LOWER MINNESOTA RIVER WATERSHED DISTRICT

Executive Summary for Action

Lower Minnesota River Watershed District Board of Managers Meeting
Monday, November 19, 2018

Item 7. F. - Project Reviews

Photo No.: 16

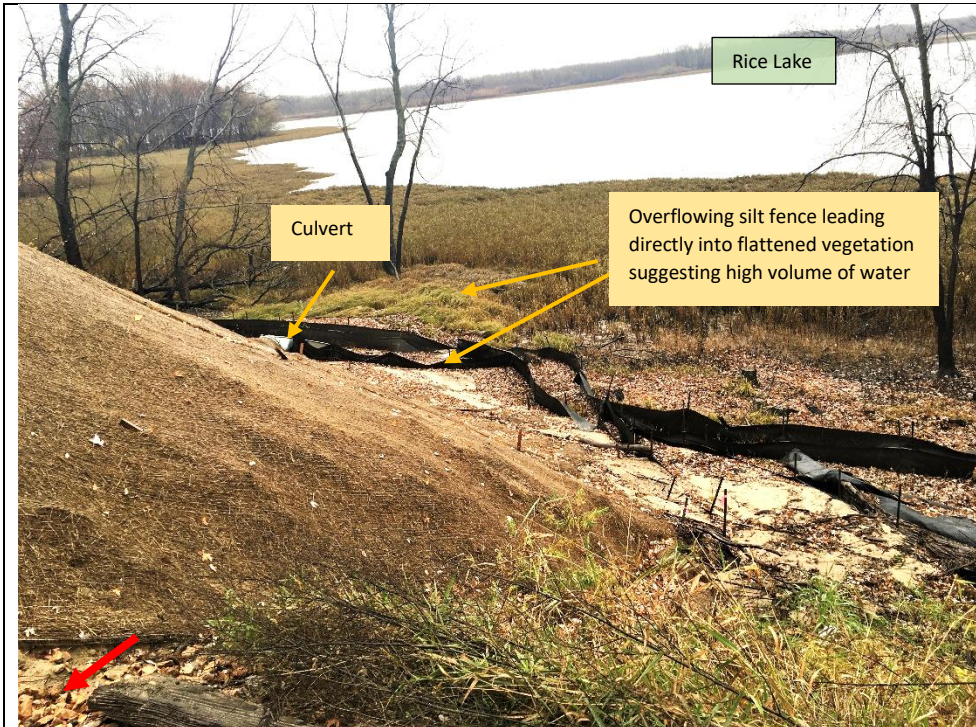
BMPs Present: Two rows of silt fencing, vegetative buffer.

Description: BMPs along Rice Lake.
